Access Compliance Report

Public Rights-of-Way

Intersection ID: 21549	Main Street: S_TRYON_ST	Cross Street: SANDY_PORTER_RD	Location: SE
ADA ID: 26A02AB41104	Ramp Type: Perp	Initial Pass/Fail: Pass	Overall Compliance: No
Severity Score: 0			
Codes/Mitigation Info/Possible Solution		Field Measurements/Component Compliance

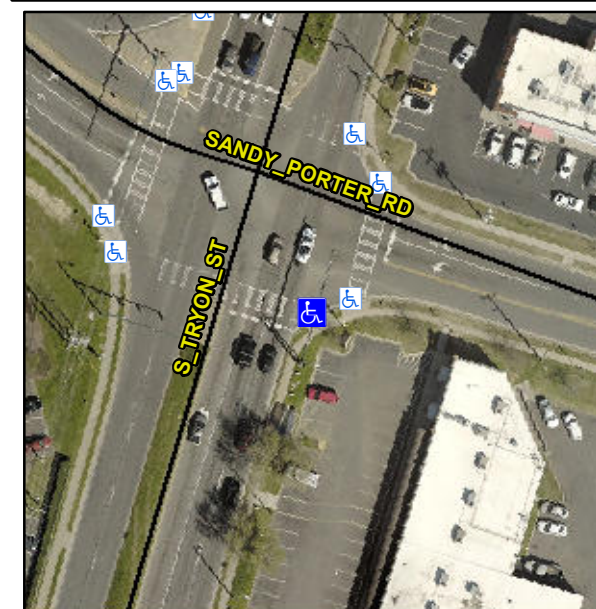
Not Found, R304.2.1, R304.2.2-Perp, R304.3.2-Para

Compliance	Description	Data	Compliance	Description	Data
N/A	Ramp Length (in)	49.0	Yes	Ramp Slope (%)	7.7
Yes	Ramp Width (in)	48.0	Yes	Ramp XSlope (%)	2.0
N/A	Flare Type LT	Sloped	N/A	Flare Type RT	N/A
N/A	Flare Slope LT (%)	4.9	N/A	Flare Slope RT (%)	7.8
N/A	Flare Traversable LT?	No	N/A	Flare Traversable RT?	No
No	Landing Length (in)	47.0	Yes	DWS Provided?	Yes
Yes	Landing Width (in)	48.0	Yes	DWS Contrast?	Yes
No	Landing Slope (%)	2.4	Yes	DWS Length (in)	24.5
Yes	Landing X Slope (%)	1.9	Yes	DWS Full Width?	Yes
N/A	Landing Curb? (Y/N)	No	Yes	DWS Offset (in)	1.5
N/A	Shared Landing?	No			
Yes	Gutter Ponding?	No	Yes	Gutter Slope (%)	2.4
Yes	Gutter Lip Ht (in)	0.0	Yes	Gutter X Slope (%)	0.9
N/A	Painted X Walk1?	Yes	N/A	Painted X Walk2?	N/A
	X Walk 1 Direction	To NW		X Walk 2 Direction	N/A
N/A	X Walk 1 Width (in)	111.0	N/A	X Walk 2 Width (in)	N/A
	X Walk 1 Slope (%)	0.5		X Walk 2 Slope (%)	N/A
	X Walk 1 X Slope (%)	2.3		X Walk 2 X Slope (%)	N/A

Yes	Ramp inside XWalk1?	Yes	N/A	Ramp inside XWalk2?	N/A
	Road Slope (%)	N/A	N/A	Clear Space?	Yes
	Road X Slope (%)	N/A	N/A	Clear Space to XWalk (in)	N/A
Yes	Any Obstructions?	No	Yes	Storm Grate/Utility Hazard?	No
	Obstruction Type			Storm Grate/Utility Type	
		N/A			N/A
			Yes	Surface Condition? (G/P)	Good

Remove & Replace Entire Ramp.
